**TOWN OF CLIFTON
ARCHITECTURAL REVIEW BOARD
REGULAR MEETING
THURSDAY, SEPTEMBER 24, 2020, 7:30 PM
*ELECTRONIC MEETING, VIA ZOOM***

1. COA Application to Review Unapproved Design Features
David Guglielmi / Infill By Design, LLC
7184 Clifton Road

RE: Certificate of Appropriateness (COA) Amended, 7184 Clifton Road

PRELIMINARY CERTIFICATE OF APPROPRIATENESS
CLIFTON ARCHITECTURAL REVIEW BOARD
TOWN OF CLIFTON, VIRGINIA
APPLICATION FOR CERTIFICATE OF
APPROPRIATENESS

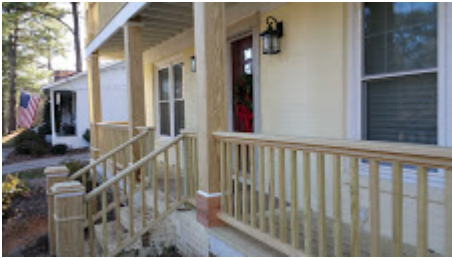
The first image is our suggestion for the front porch/stair rails.

The second and third images are our suggestions for the guard rails along the front retaining wall where required by code and the basement areaway.

The fourth image is the as-built rear retaining wall.

Front Porch and Rear Areaway Rail Detail-
Wood painted flat white

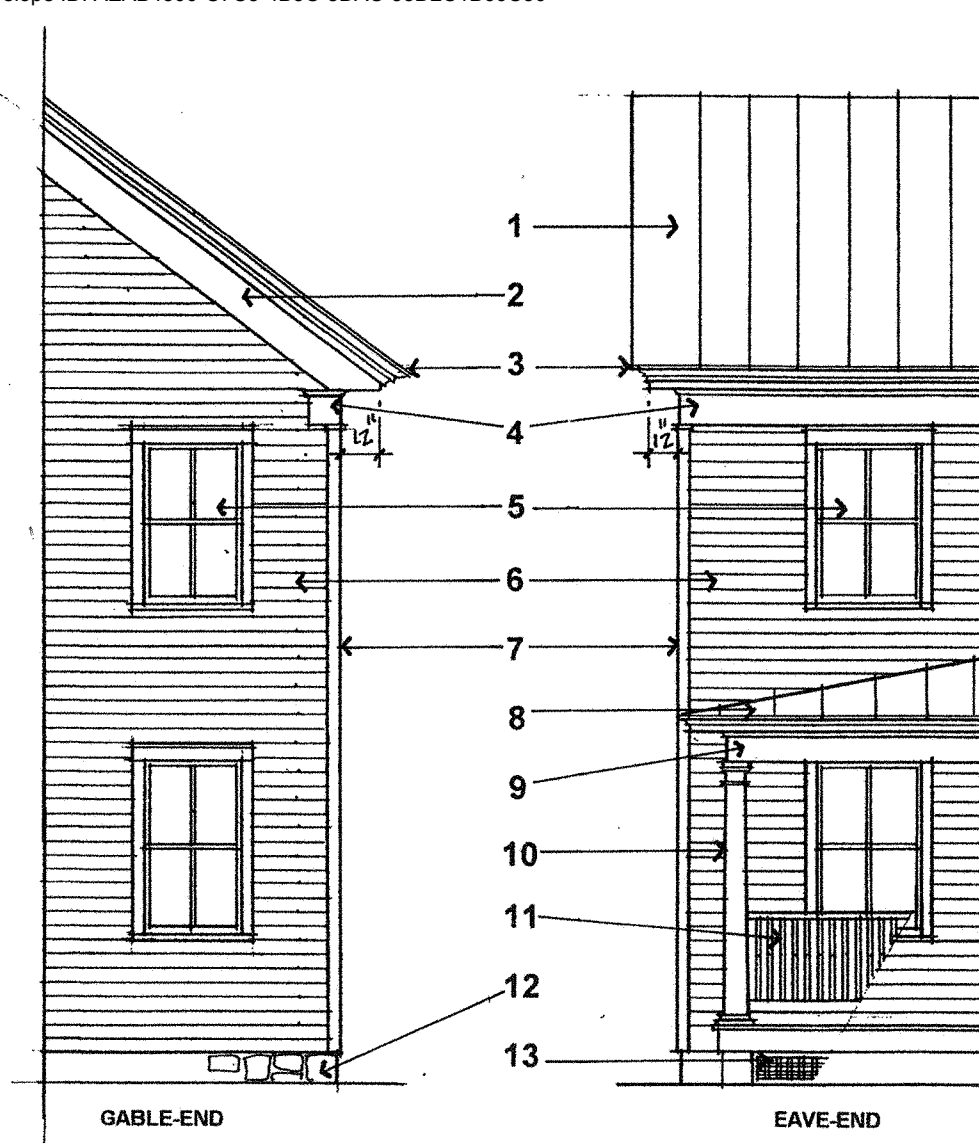
3. Porch Railing

Please submit a drawing or picture with material specification of your intended modification

The ARB has accepted Mr. Guglielmi's proposal to remove the vinyl railing system and to replace with wooden posts and railing to be painted white as per the original COA (photo of re-approved wooden post/railing system attached).

TYPICAL ARCHITECTURAL ELEMENTS

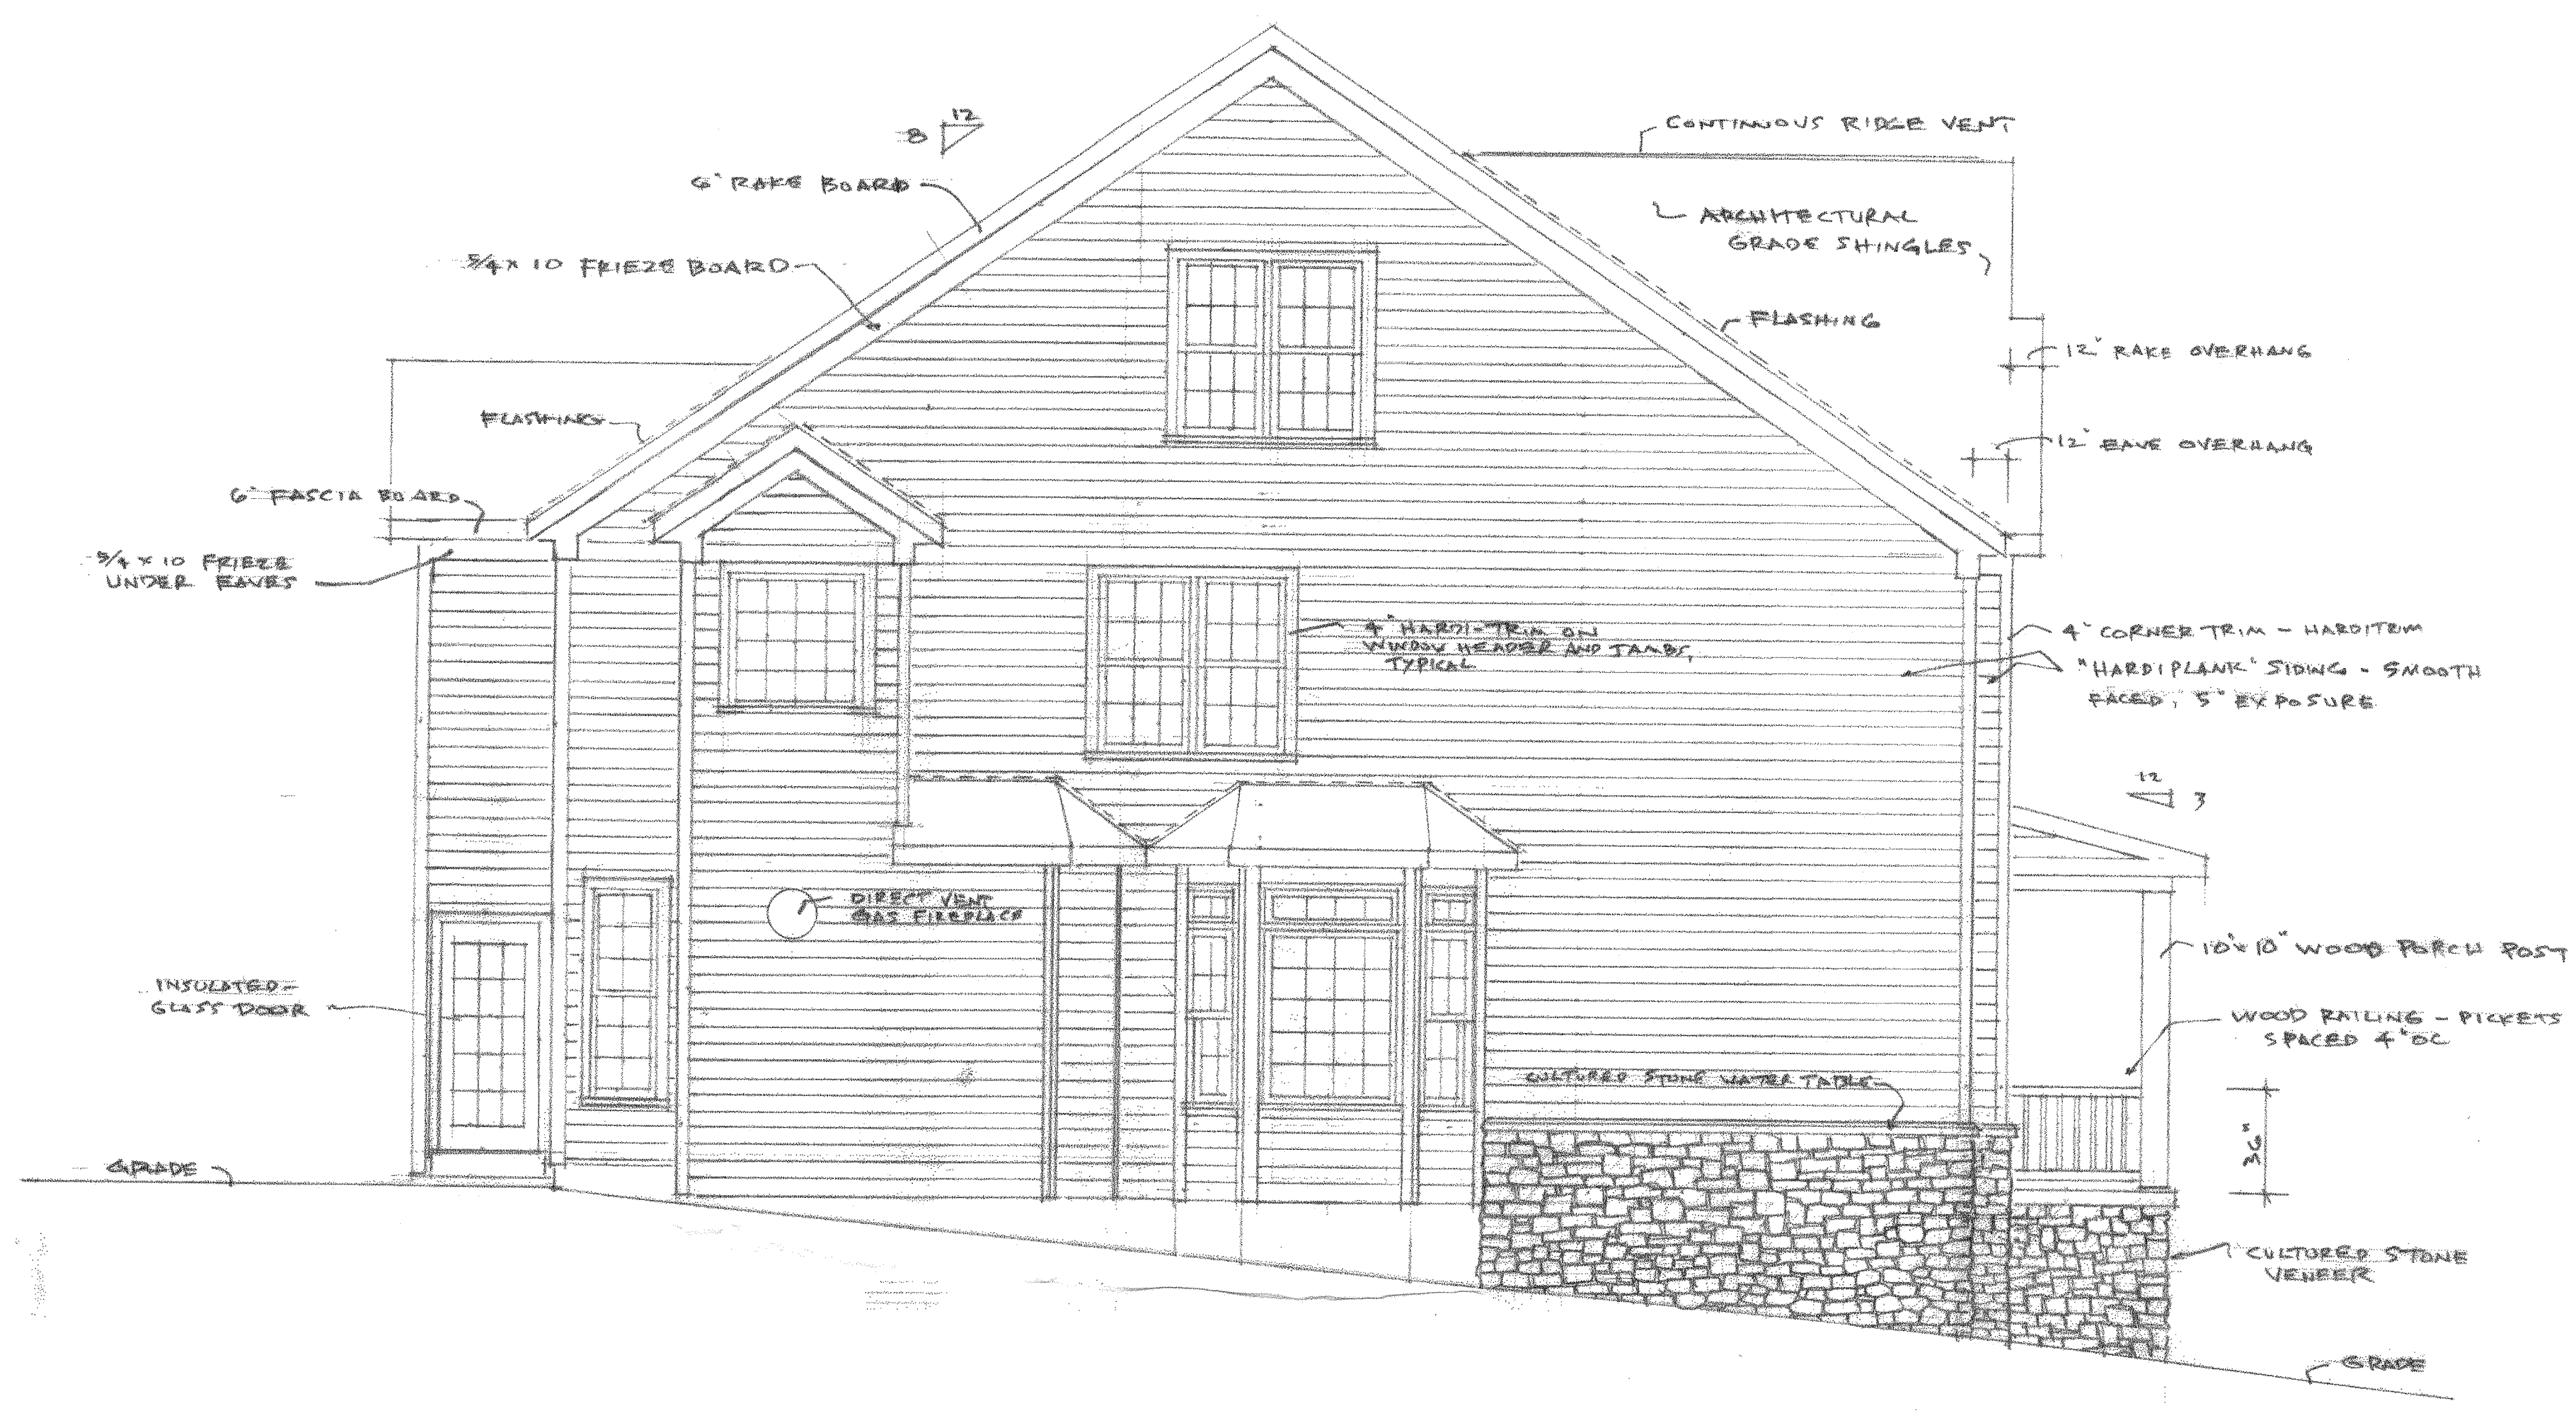
The approved COA was based on the rake detail specifically noted on the COA. Despite your contention of other examples in town or your construction errors, the approved COA is conditioned on adherence to the requirements of that approval. Please submit a drawing or picture with material specification of your proposed modification for ARB review.

Mr. Guglielmi has agreed to modify the six (6) box returns to comply with the originally-approved frieze-board return style by removing and replacing the trim (photo attached of non-compliant return and original style approved).

Compared to frieze-board molding returns as submitted and approved by the ARB:

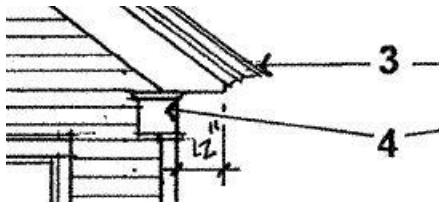
7. The “dog-eared” eave returns were not approved. Mr. Guglielmi has agreed to modify all non-conforming box returns to match the frieze-board molding returns as detailed below.

4 1-1/4" thick frieze board usually 10" - 12" wide. Returns around corner with or without cap molding.
